**RE: University of Sydney, Campus Improvement Program 2014-2020
(SSD 13_6123) – Further Submission**

University of Sydney Campus Improvement Program 2014-2020

SSD 13_6123

Further Submission to NSW Planning and Infrastructure
25 August 2014

Figure 2.(bottom) – Proposed Buildings for Demolition

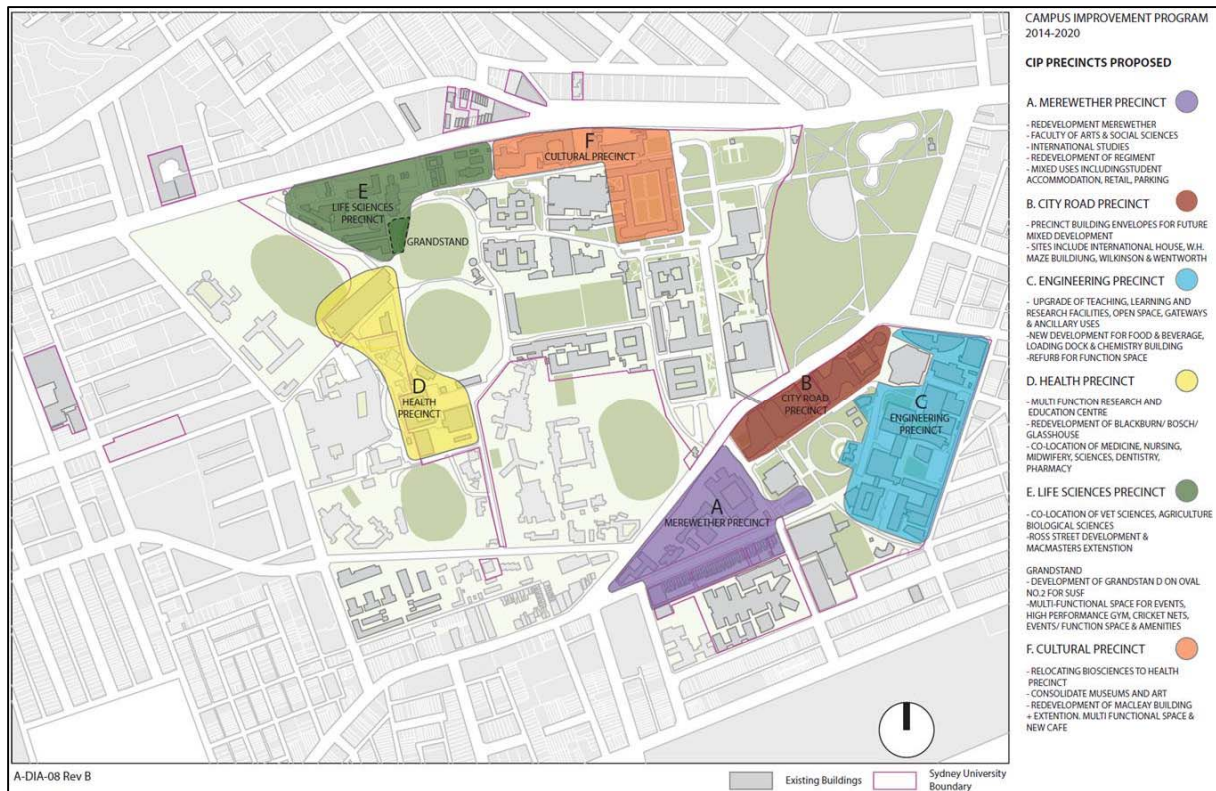
The proposed demolition of the Chemical Engineering Building is not supported. The proposed alterations to the Electrical Engineering Building should be designed with regard to the impact upon the original building. A Conservation Management Plan should be developed for the Engineering Precinct as a whole and identified significant modernist buildings should be retained and conserved.

The Chemical Engineering Building is classed as being of high heritage significance and as such the City does not support its demolition which is inconsistent with the policies of the Grounds Conservation Management Plan. Notwithstanding this recommendation, the proposed envelope will intrude on views to Cadigal Green from the boardwalk's north-west splay, and result in the loss of existing canopy trees between the Civil and Chemical engineering buildings.

The University's response acknowledges the design response necessary for the proposed alterations to the Electrical Engineering Building which is supported, and amends the buildings proposed for demolition (Dwg A-DIA-03 Rev C) to retain the PNR Building and the Mechanical Engineering Building in total.
